Project	<b>IEEE 802.16 Broadband Wireless Access Working Group</b> < <a href="http://ieee802.org/16">http://ieee802.org/16</a> >	
Title	<b>Remedy for relaying compressed DL-MAP/UL-MAP, HARQ-MAP and SUB-DL-UL-MAP</b>	
Date Submitted	<b>2007-07-18</b>	
Source(s)	Kanchei (Ken) Loa, Yi-Hsueh Tsai, Hua-Chiang Yin, Shiann Tsong Sheu, Yung-Ting Lee, Youn-Tai Lee	Voice: +886-2-27399616 Fax: +886-2-23782328 <a href="mailto:loa@iii.org.tw">loa@iii.org.tw</a>
	Institute for Information Industry 8F, No. 218, Sec. 2, Dunhua S. Rd., Taipei City 106, Taiwan	
	Hongyun Qu, Mary Chion ZTE Corporation	<a href="mailto:qu.hongyun@zte.com.cn">qu.hongyun@zte.com.cn</a> <a href="mailto:mchion@zteusa.com">mchion@zteusa.com</a>
Re:	IEEE 802.16j-07/019: "Call for Technical Comments Regarding IEEE Project 802.16j"	
Abstract	This contribution proposes the enhanced remedy of relaying compressed DL-MAP and UL-MAP, HARQ-MAP and SUB-DL-UL-MAP, which do not have MAC headers and management message types.

# Remedy for relaying compressed DL-MAP/UL-MAP, HARQ-MAP and SUB-DL-UL-MAP

Figure xxx –Relaying DCD/UCD procedure

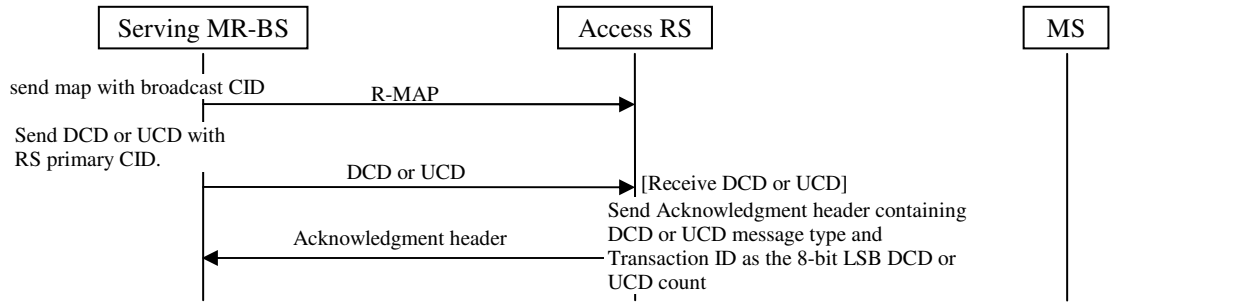
Upon receiving the DCD/UCD message with RS primary CID, as shown in Figure xxx, the RS shall acknowledge the reception of DCD or UCD messages over primary management connection by sending an acknowledgment header (See 6.3.2.1.2.2.2.3). The Transaction ID of the ACK header shall be set to the

Configuration Change Count of DCD or UCD message. There shall be one ACK header per message. The RS may retransmit DCD/UCD message if the acknowledgment header is not received at the expiration of T52 timer.

Figure yyy – DCD/UCD broadcasting with centralized scheduling

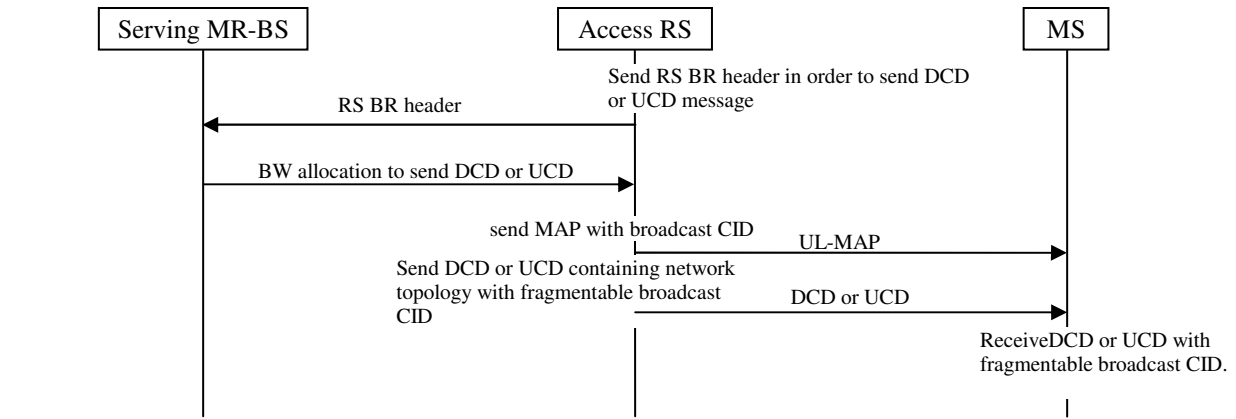
Under centralized scheduling, as shown in Figure yyy, the RS should request bandwidth on the access link to broadcast the DCD/UCD message with fragmentable broadcast CID.
